City of Portland, Maine - Building or Use Permit Application

Permit No: 01-0778	Issue Date: JUL 23 2001	CBL: 432 A006001
-----------------------	----------------------------	---------------------

Location of Construction: 13 Arcadia St	Owner Name: Quatrano Theresa M Feroci	Owner Address: 11 Arcadia St	Phone: 207-874-0554
Business Name: n/a	Contractor Name: Gough, Michael	Contractor Address: 13 Candlewyke Road Windham	Phone: 2076373199
Lessee/Buyer's Name: n/a	Phone: n/a	Permit Type: Multi Family	Zone: R-5

13 ARCADIA ST. 3<sup>rd</sup> FLOOR

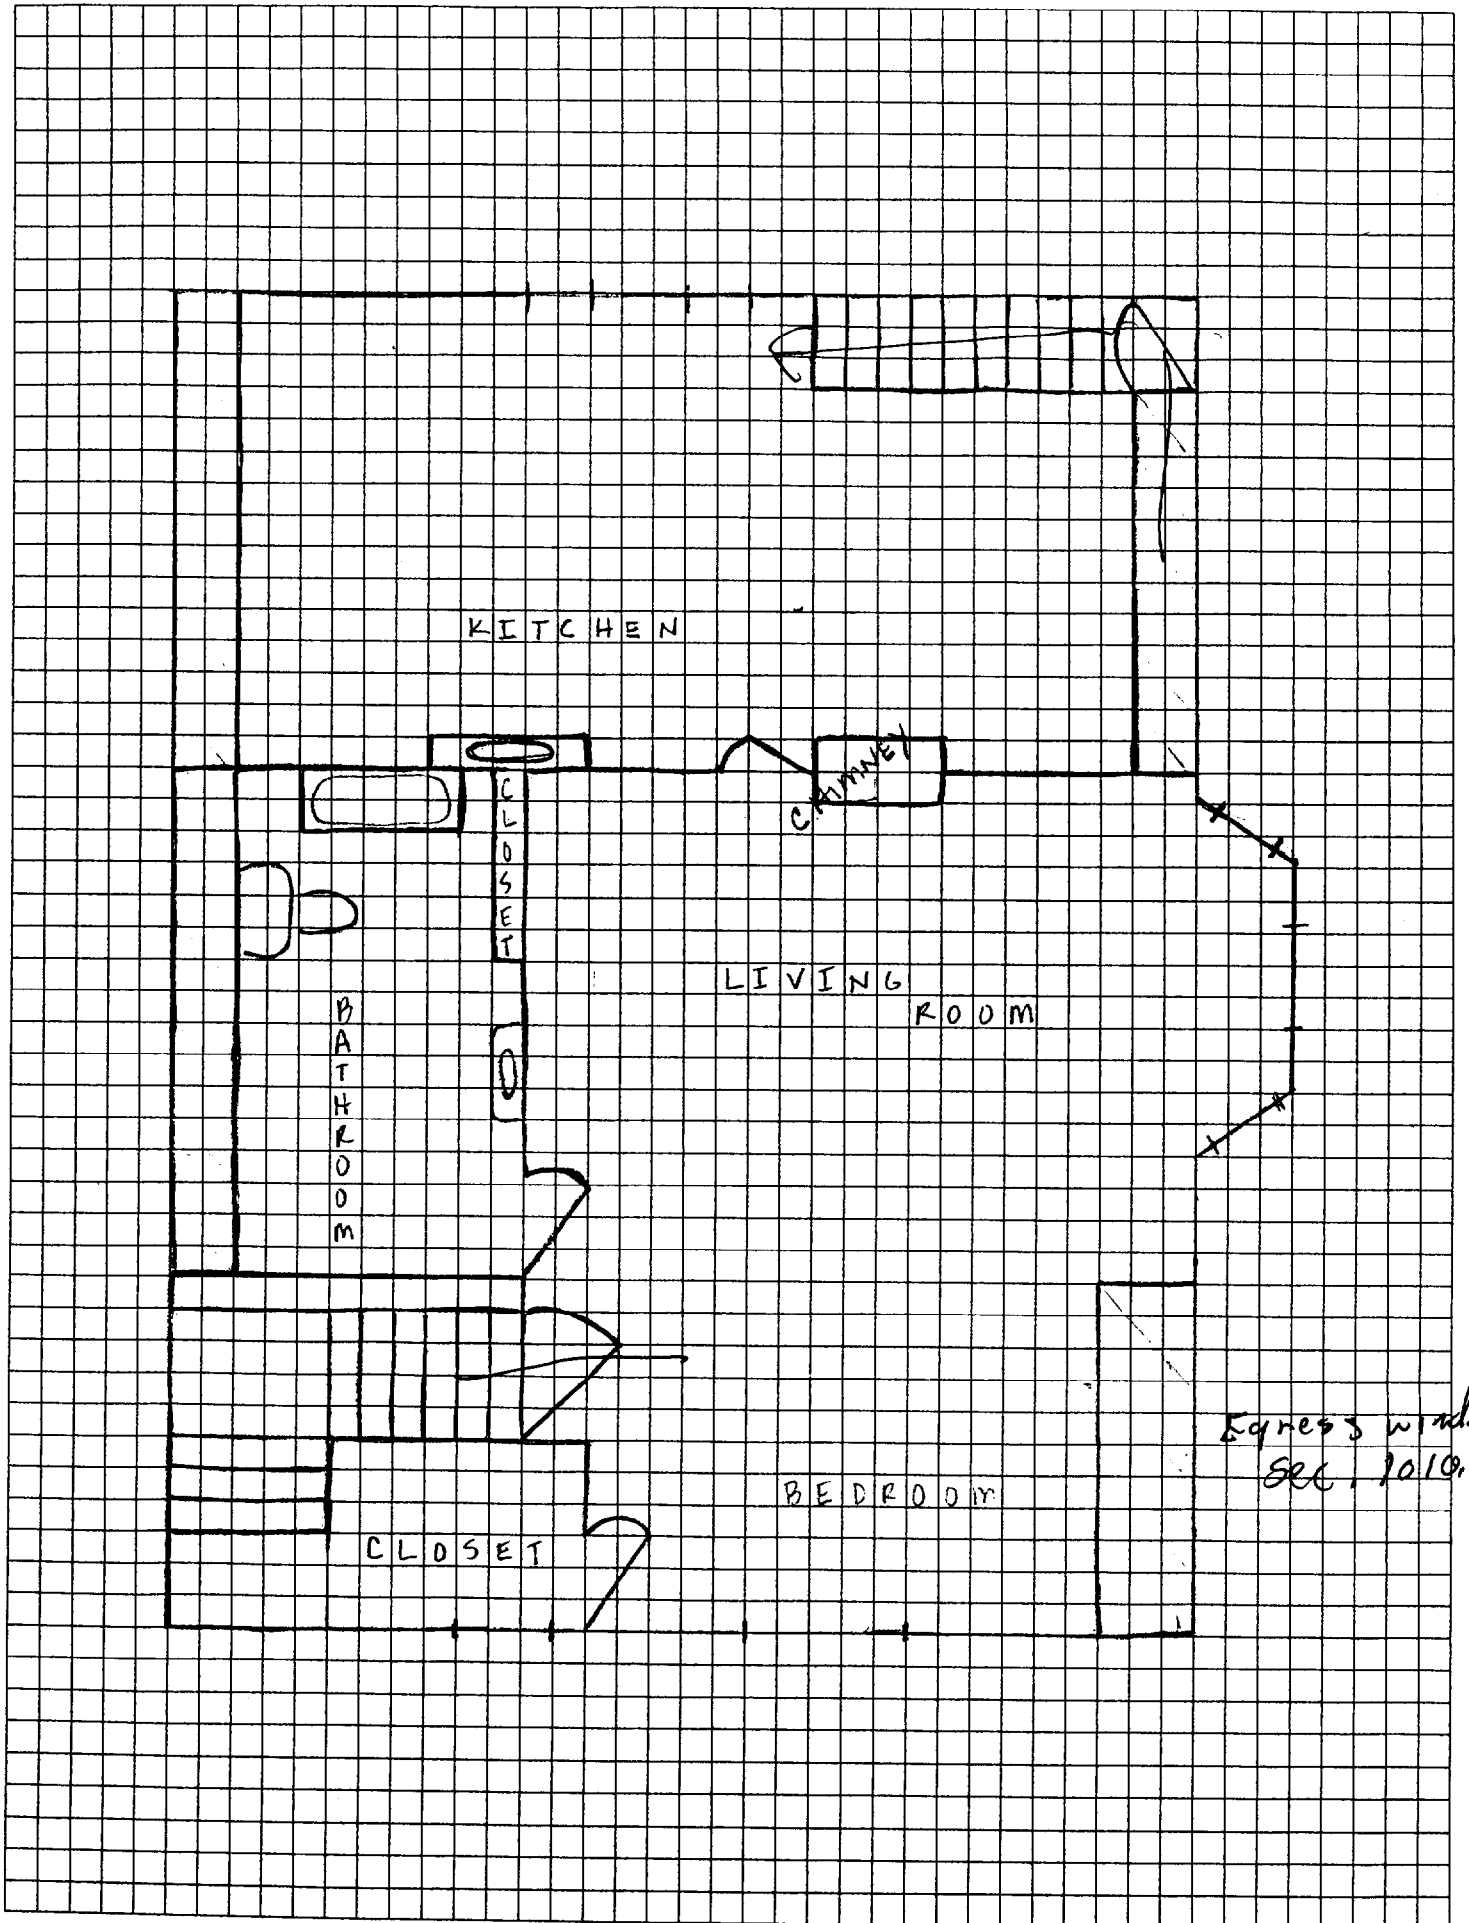
Egress window  
SEC. 7010.4
